December 1, 2021 – REGULAR MEETING

Meeting Date:	December 1, 2021	Meeting Title:	Planning Commission
Submitting Department:	Planning	Presenter:	Tyler Valentine
Agenda Item:	P21-268 Sketch Plan for a new 67,000 sf mixed-use building at the properties addressed at 50 S. Cache Street and 45 & 75 E. Pearl Avenue	Public Comment:	Yes

Type of Review	Status	Dates			
		Sent	Due	Received	Remarks
Contact Notes (11/9/2021 4:35 PM SM) SKETCH PLAN Comments – Approved with Conditions					
P21-268 Sketch Plan ADDRESS: 50 S Cache Street OWNER: CCC's Ranch Inn, LLC APPLICANT: Northworks Architects					
11/9/2021 Scott Mohror, (307) 733-3079					
DATE OF SUBMITTAL: 10/18/2021 DATE OF MATERIALS: Report 10/18/2021; Utility Plan 11/3/2021 REVISION NO.: 00

BUILDING ELEVATIONS
SCALE: 3/32" = 1'-0"

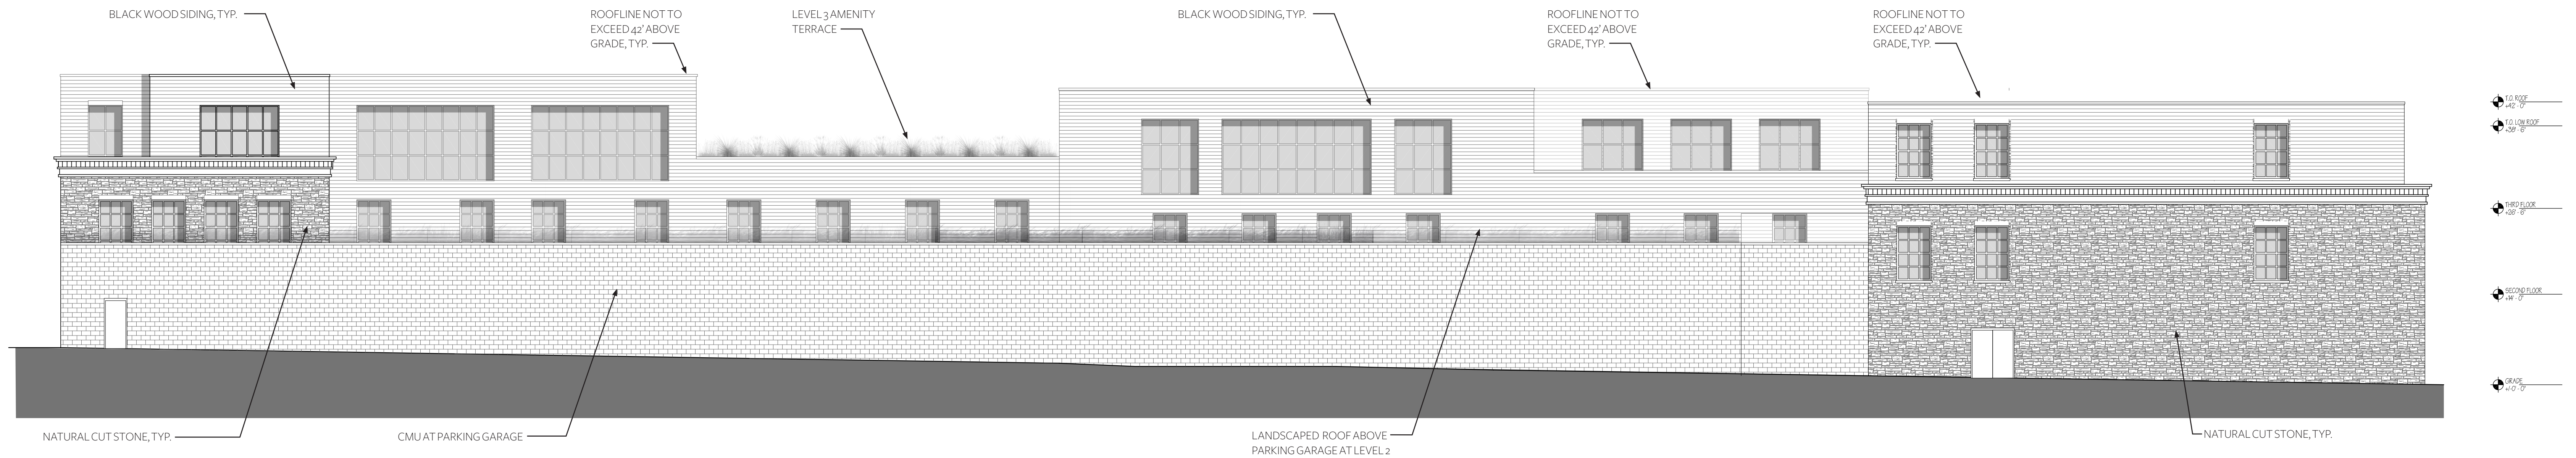
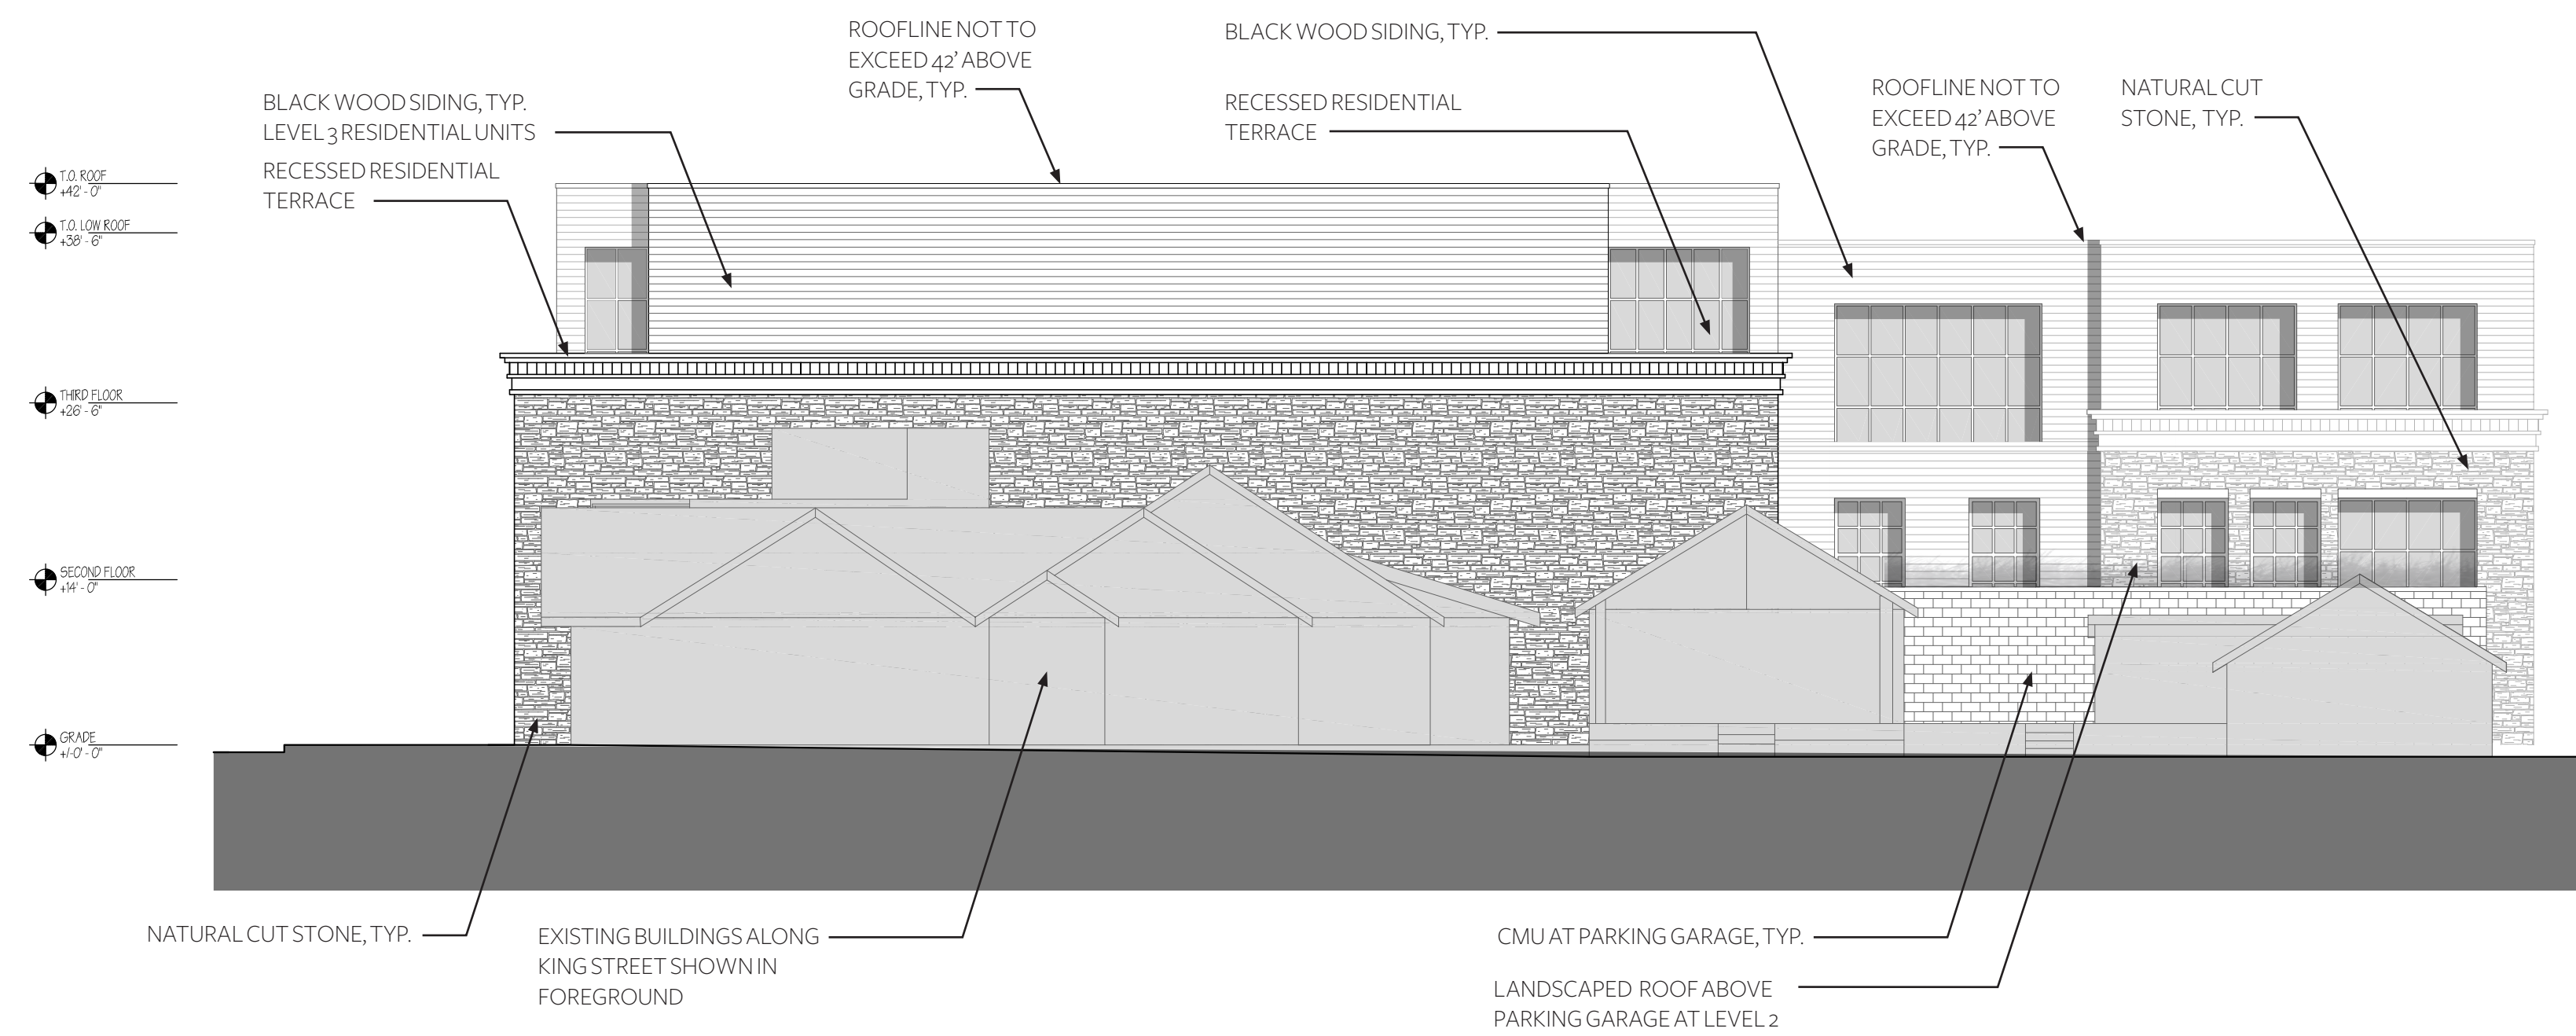
4. First story windows/transparency: The amount of glazing should be similar to traditional Jackson buildings (see Sec. 1.21). Concept drawings show street level floor to ceiling windows which is too much, might try a kick plate or some other techniques to reduce glazing. The second story windows also show more transparency than traditional structures.

Since the comment was made, the applicant has significantly reduced glazing at both street level and upper stories using a variety of techniques that more closely align with traditional structures. The proposed building design was unanimously approved by the DRC on October 13, 2021, and features kick plates below the street level storefront glazing, and a variety of punched window types on the second floor.

WEST UTILITY SITE PLAN
SCALE: 1" = 40' (11X17)

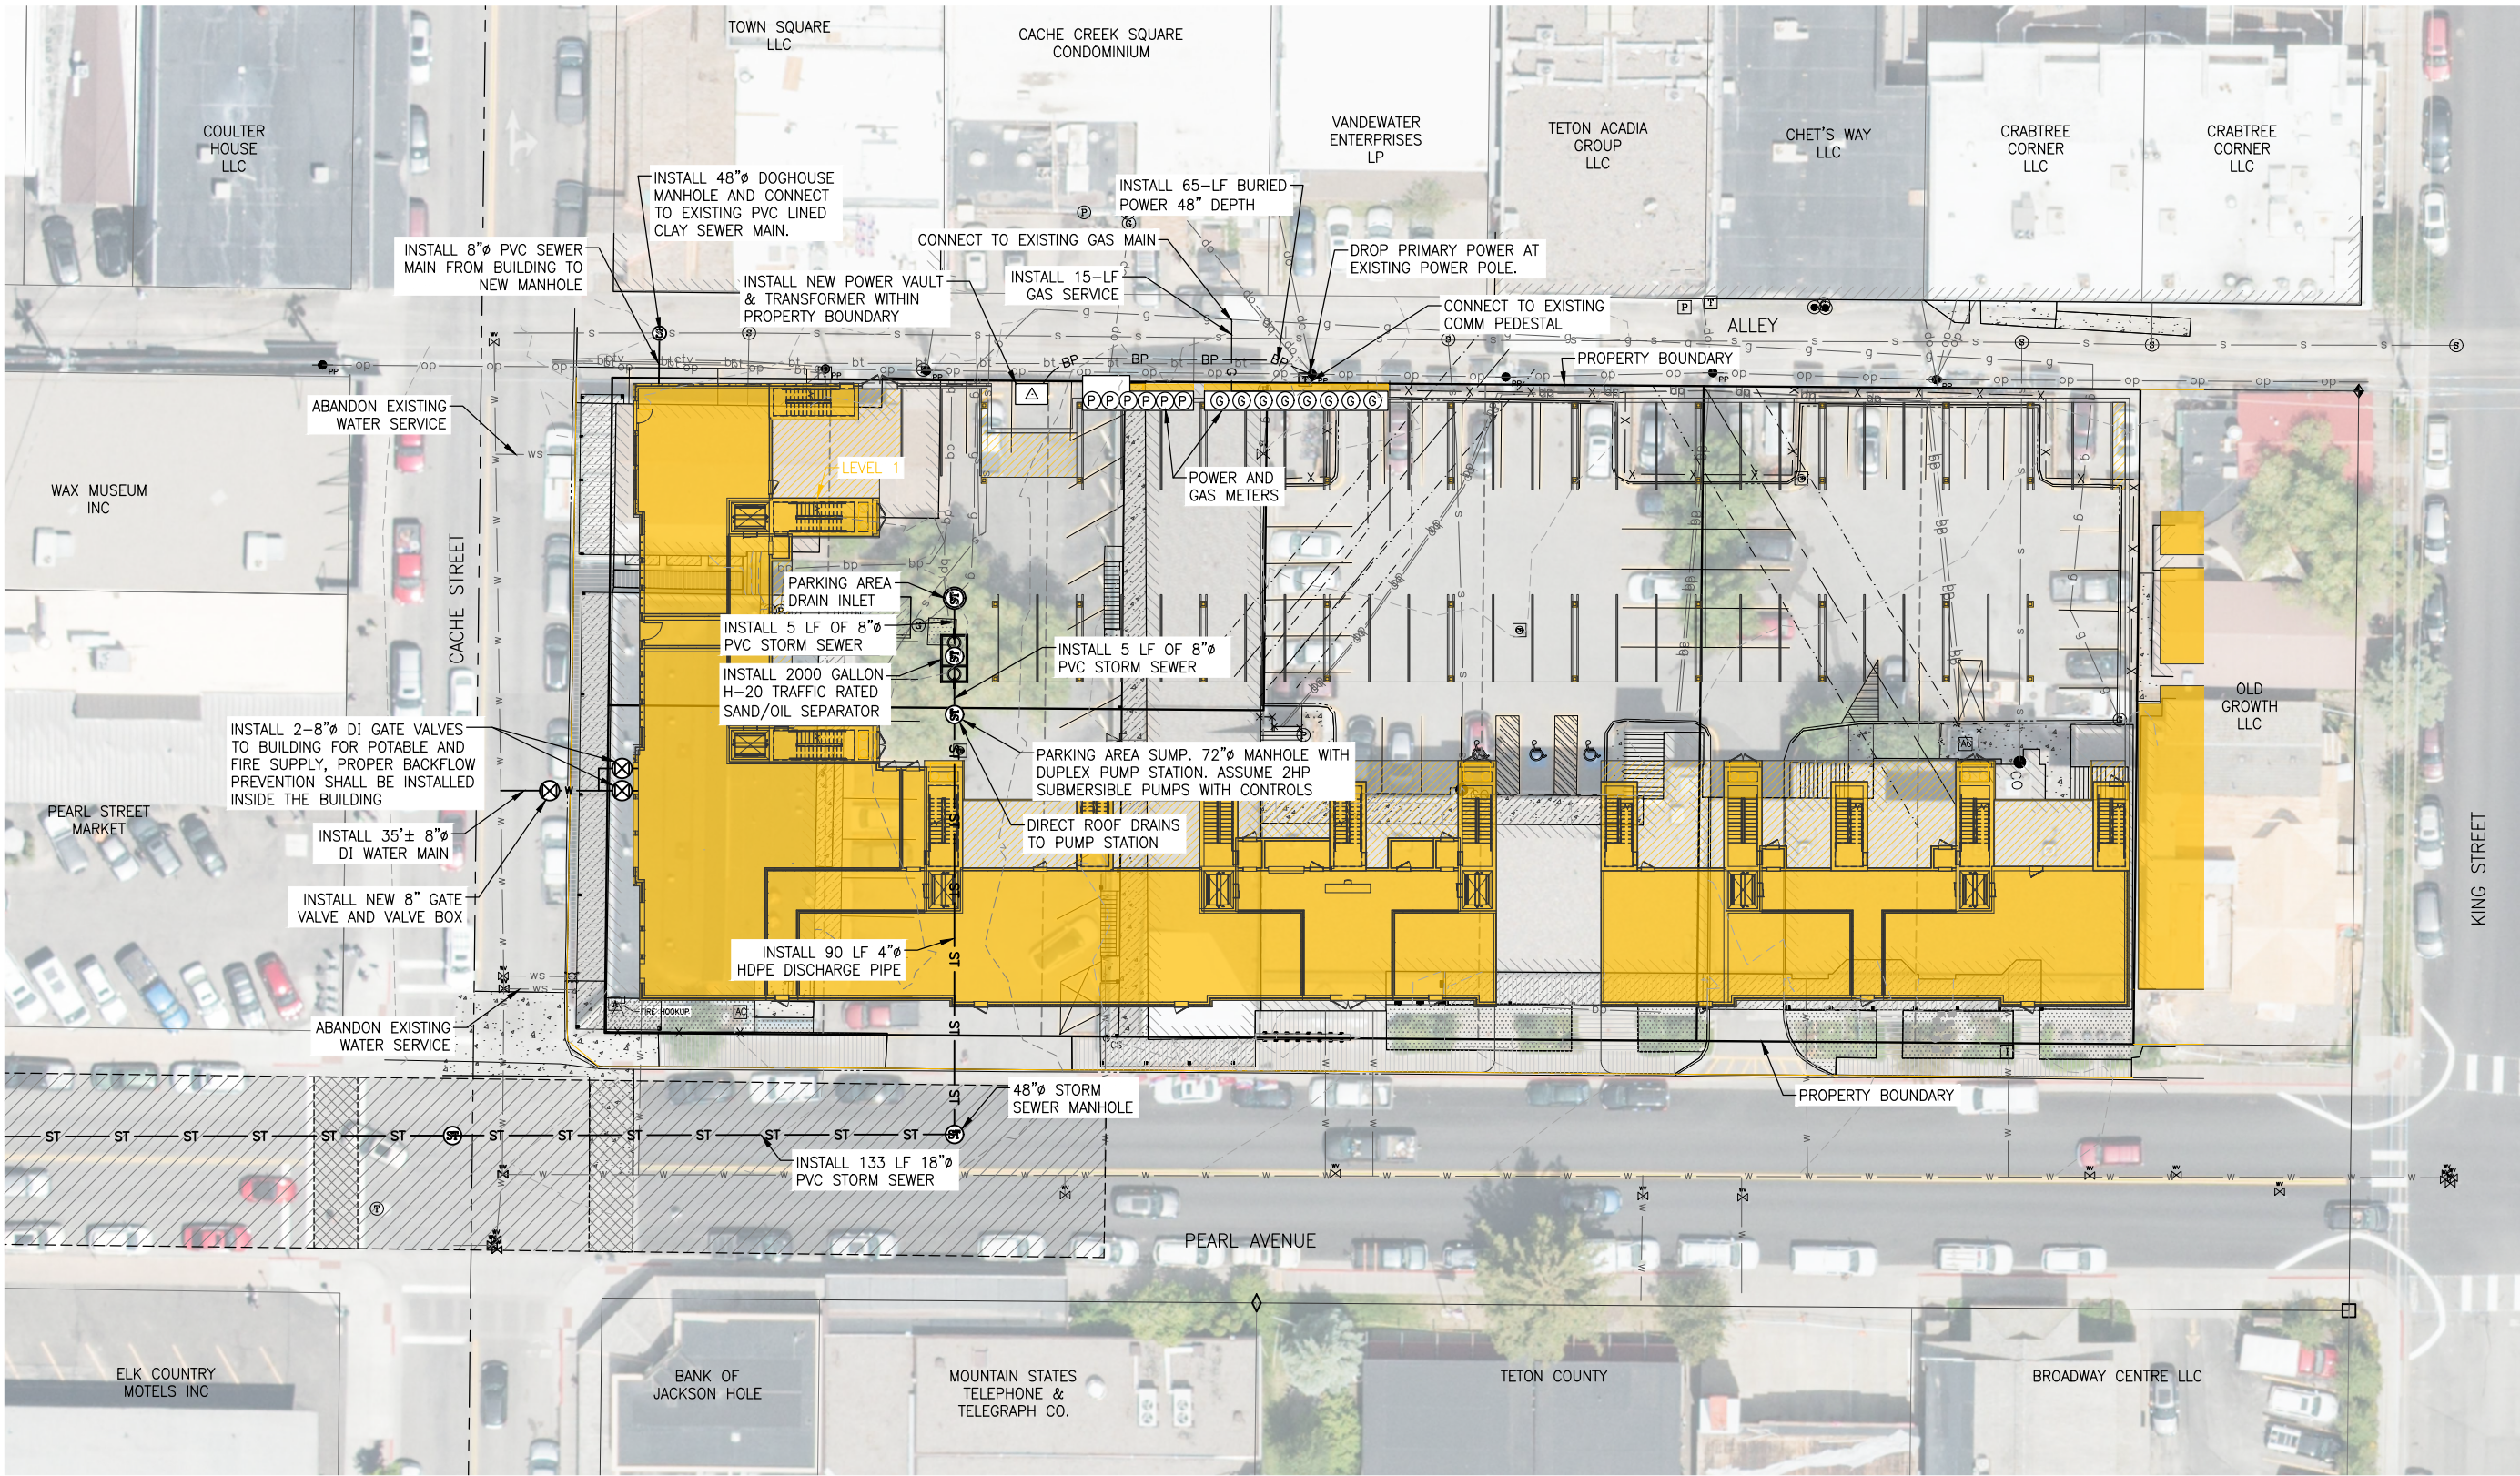
18. Include the water services to be abandoned on the demolition plan. Coordinate with Town of Jackson on locations of existing water services, Town records vary from the survey provided.

19. A detailed potable water system plan shall be provided on the plans consistent with the LDR's. The plan shall show the calculations for domestic and fire water demands. This plan shall include all backflow device and meter locations.

24. Provide a detailed sanitary sewer system on the plans consistent with the LDR's. Existing manholes in suitable condition shall be used for connection to the main, replacement of unsuitable manholes may be required.
